SUBJECT: PALISADES NUCLEAR PLANT- STAFF ASSESSMENT OF INFORMATION PROVIDED PURSUANT TO TITLE 10 OF THE *CODE OF FEDERAL REGULATIONS* PART 50, SECTION 50.54(f), SEISMIC HAZARD REEVALUATIONS RELATING TO RECOMMENDATION 2.1 OF THE NEAR-TERM TASK FORCE REVIEW OF INSIGHTS FROM THE FUKUSHIMA DAI-ICHI ACCIDENT (TAC NO. MF3786)

STAFF ASSESSMENT BY THE OFFICE OF NUCLEAR REACTOR REGULATION

RELATED TO SEISMIC HAZARD AND SCREENING REPORT

PALISADES NUCLEAR PLANT

Figure 3.3- 1 Plot Comparing the Staff's and the Licensee's Median Amplification Functions and Uncertainties for the Palisades site.

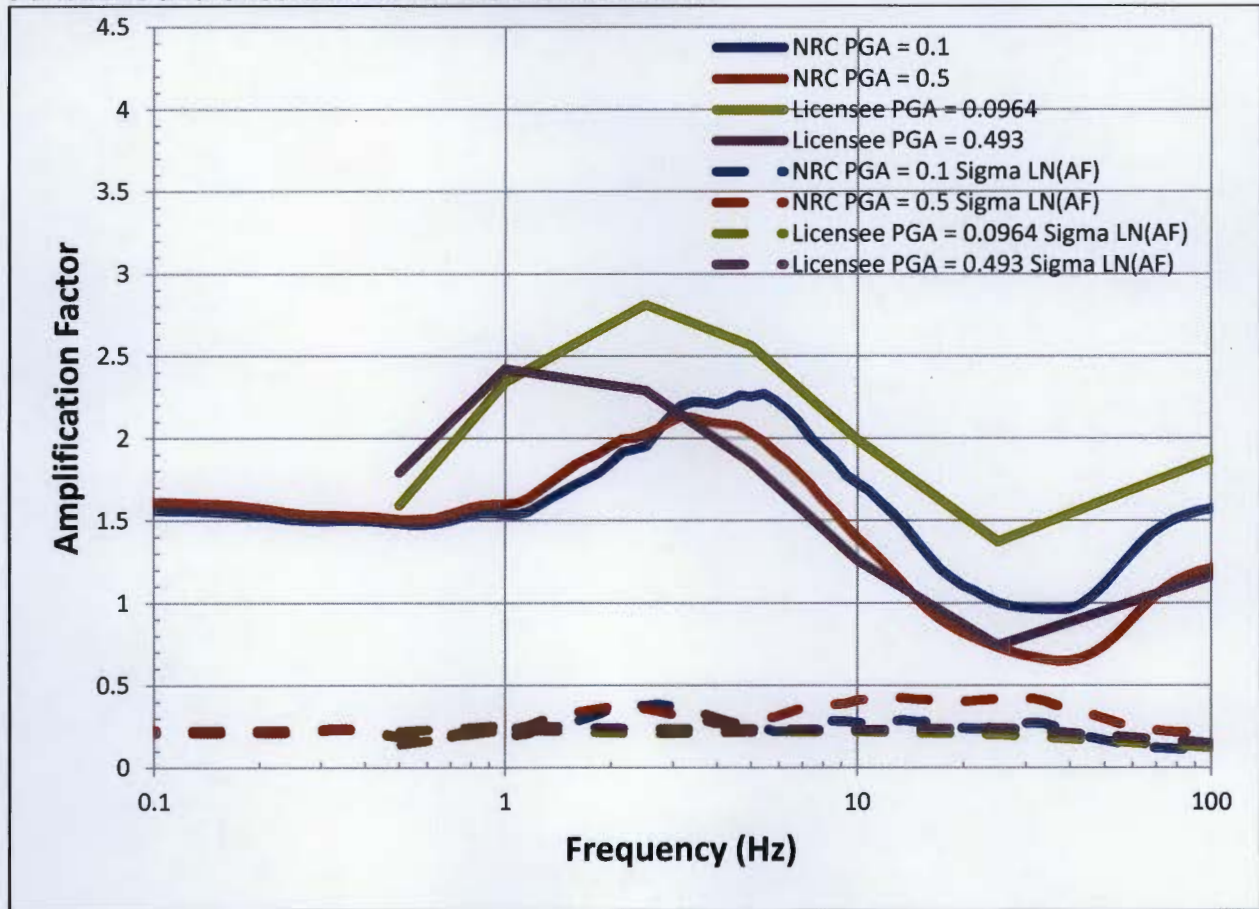
Figure 3.3-2 of this assessment shows a comparison on the staff's and the licensee's median site amplification functions and associated uncertainties (± 1 standard deviation) for two of the eleven input loading levels. Peaks in amplification functions occur between approximately 1 and 5 Hz in

both staff and licensee curves. Differences in the amplification functions developed by the staff and licensee are due to the licensee's use of six profiles, as described above, with three of the six profiles having reference rock directly beneath the soil layers.

The licensee's approach to modeling the subsurface rock properties and their uncertainty results in higher amplification factors at low and high frequencies compared to those developed by the staff. As shown in Figure 3.3-3 of this assessment, these differences in site response analysis have a moderate impact on the control point seismic hazard curves and the resulting GMRS as discussed below. Specifically, hazard curves developed by the licensee are higher than those developed by the staff at 1.0 Hz, but consistent at other frequencies. These differences are the result of differences in site response analysis. Appendix B of the SPID provides guidance for performing site response analyses, including capturing the uncertainty for sites with less subsurface data; however, the guidance is neither entirely prescriptive nor comprehensive. As such, alternative approaches in performing site response analyses, including the modeling of uncertainty, are acceptable for this application.

Figure 3.4-1 Comparison of the Staff's GMRS with Licensee's GMRS and the SSE for the Palisades site

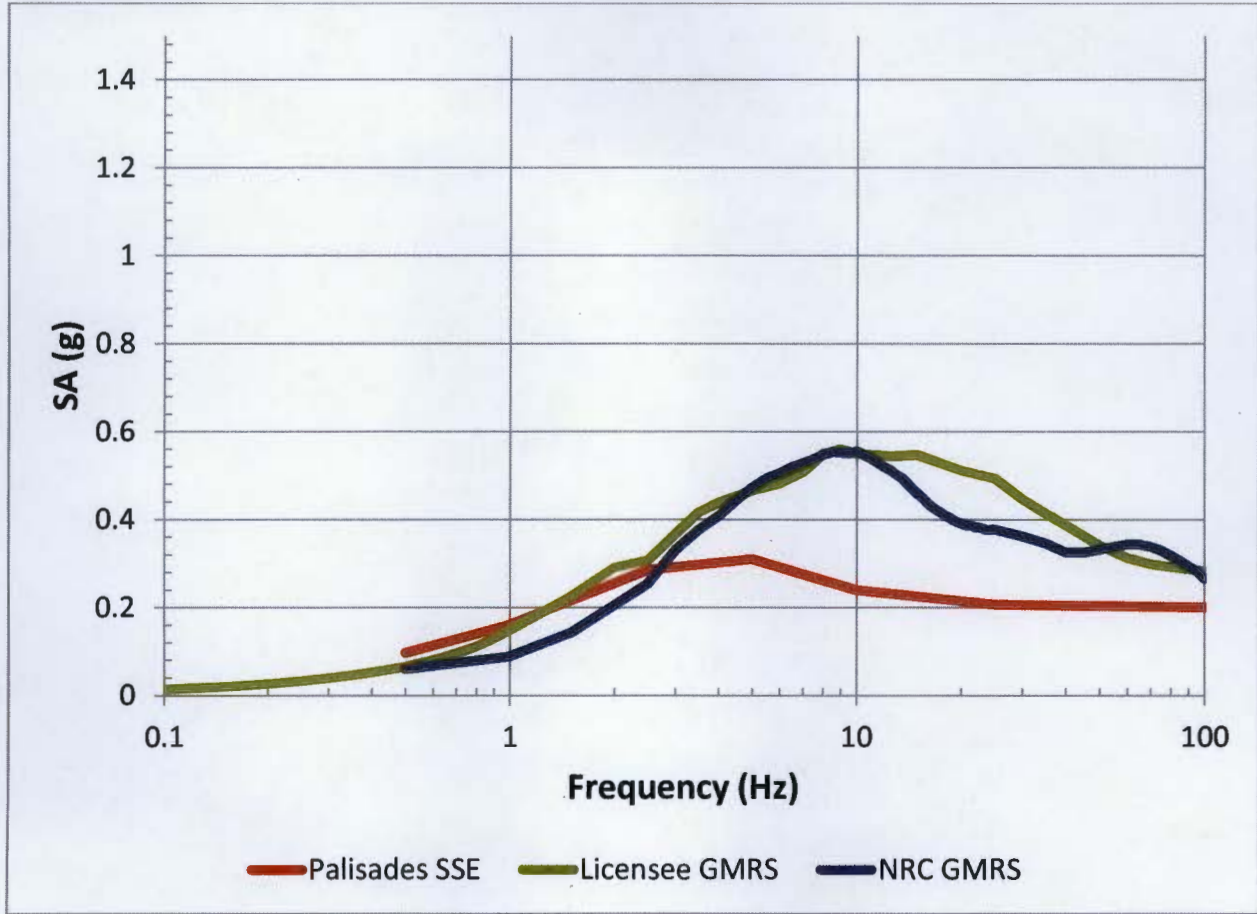
The staff independently calculated the 10^{-4} and 10^{-5} UHRS using the results of its confirmatory PSHA and site response analysis, as described in Sections 3.2 and 3.3 of this staff assessment, respectively. Figure 3.4-1 of this assessment shows a comparison of the GMRS determined by the licensee to that determined by the staff.

As shown in Figure 3.4-1 of this assessment, the licensee's GMRS shape is generally similar to that calculated by the staff. At frequencies where the amplitude of the GMRS determined by the licensee is different from that determined by the staff, the licensee's generally exceeds that of the staff. These differences in GMRS are the result of differences in the site response analyses performed by the licensee and staff, as discussed in Section 3.3 above. The staff concludes that these differences are acceptable for this application because the licensee followed the guidance provided in the SPID with respect to both the PSHA and site response analysis for the Palisades site.

The staff confirms that the licensee used the present-day guidance and methodology outlined in RG 1.208 and the SPID to calculate the horizontal GMRS, as requested in the 50.54(f) letter. The staff performed both a PSHA and site response confirmatory analysis and achieved results consistent with the licensee's horizontal GMRS. As such, the staff concludes that the GMRS
